Access Compliance Report Public Rights-of-Way (Curb Ramps)

Intersection ID: 10035098 Main Street: PROVIDENCE_RETREAT_LN Cross Street: N/A Location: W

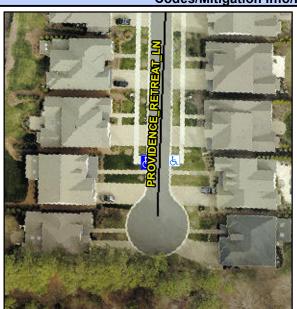
Severity Score: Ramp Type: Perp **Overall Compliance: No** 10 ADA ID: E449E7F2841A Initial Pass/Fail: Fail

Field Measurements/Component Compliance							
Comp	liance Description	Data	Comp	liance	Description	Data	
N/A	Ramp Length (in)	96.0	Yes	Ramp	Slope (%)	5.0	
No	Ramp Width (in)	47.0	Yes	Ramp	XSlope (%)	2.6	
N/A	Flare Type LT	N/A	N/A	Flare	Type RT	N/A	
N/A	Flare Slope LT (%)	N/A	N/A	Flare	Slope RT (%)	N/A	
N/A	Flare Traversable LT?	N/A	N/A	Flare	Traversable RT?	N/A	
N/A	Landing Length (in)	N/A	N/A	DWS	Provided?	N/A	
N/A	Landing Width (in)	N/A	N/A	DWS	Contrast?	N/A	
N/A	Landing Slope (%)	N/A	N/A	DWS	Length (in)	N/A	
N/A	Landing X Slope (%)	N/A	N/A	DWS	Full Width?	N/A	
N/A	Landing Curb? (Y/N)	N/A	N/A	DWS	Offset (in)	N/A	
N/A	Shared Landing?	N/A					
N/A	Gutter Ponding?	N/A	N/A	Gutte	r Slope (%)	N/A	
N/A	Gutter Lip Ht (in)	N/A	N/A	Gutte	r X Slope (%)	N/A	
N/A	Painted X Walk1?	No	N/A	Paint	ed X Walk2?	N/A	
	X Walk 1 Direction	То Е		X Wa	lk 2 Direction	N/A	
N/A	X Walk 1 Width (in)	N/A	N/A	X Wa	lk 2 Width (in)	N/A

X Walk 1 Slope (%)	3.2		X Wa	lk 2 Slope (%)	N/A	
	X Walk 1 X Slope (%)	3.8		X Wa	lk 2 X Slope (%)	N/A	
N/A	Ramp inside XWalk1?	N/A	N/A	Ramp	inside XWalk2?	N/A	
	Road Slope (%)	N/A	N/A	Clear	Space?	N/A	
	Road X Slope (%)	N/A	N/A	Clear	Space to XWalk (in)	N/A	
N/A	Any Obstructions?	N/A	N/A	Storm	n Grate/Utility Hazard?	N/A	
	Obstruction Type			Storm	n Grate/Utility Type		
		N/A				N/A	
			Yes	Surfa	ce Condition? (G/P)	Good

Possible Solution		Fleid Mea
Possible Solutions:	Complia	nce Description
Remove & Replace Entire Ramp.	N/A F	Ramp Length (in)
·	No F	Ramp Width (in)
	N/A	Flare Type LT
	N/A	Flare Slope LT (%)
	N/A I	Flare Traversable LT
	N/A l	anding Length (in)
Surveyor Notes:	N/A l	_anding Width (in)
N/A	N/A l	anding Slope (%)
	N/A l	anding X Slope (%)
	N/A l	anding Curb? (Y/N)
	N/A	Shared Landing?
PROW/ADA:	N/A	Gutter Ponding?
Not Found, R304.5.1	N/A	Gutter Lip Ht (in)
·	N/A F	Painted X Walk1?
		K Walk 1 Direction
	N/A	K Walk 1 Width (in)
		K Walk 1 Slope (%)
		X Walk 1 X Slope (%)
	N/A F	Ramp inside XWalk1
	F	Road Slope (%)
	F	Road X Slope (%)
	N1/A	A Ol t t
